SL1047A-02-S

Safety Service Note

SL1047A - Scienlab Charging Discovery System High-Power Series

POSSIBLE SHOCK HAZARD

Figure 1: Plug-in slot before modification

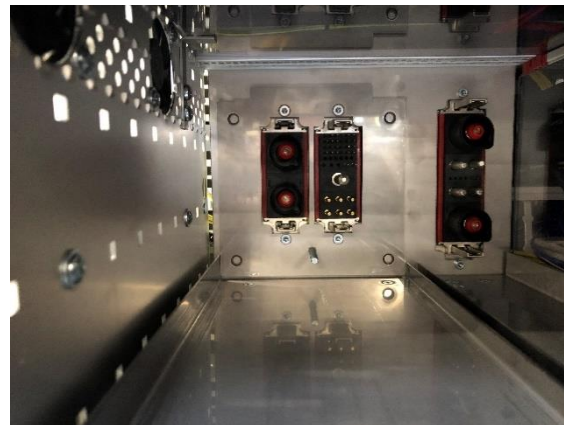
To exclude inappropriate use of the specified adapter, a minor mechanical modification in the HP-CDS (SL1047A) is necessary to ensure that the CEE-Inlet cannot be used with the HP-CDS (SL1047A).

The plug-in slot at the HP-CDS (SL1047A) needs to be mechanically modified to prevent the insertion of a plug-in.

Figure 2: Plug-in slot after modification

The modification is done according to the internal only service note SL1047A-03 and needs to be performed by a Keysight authorized expert.
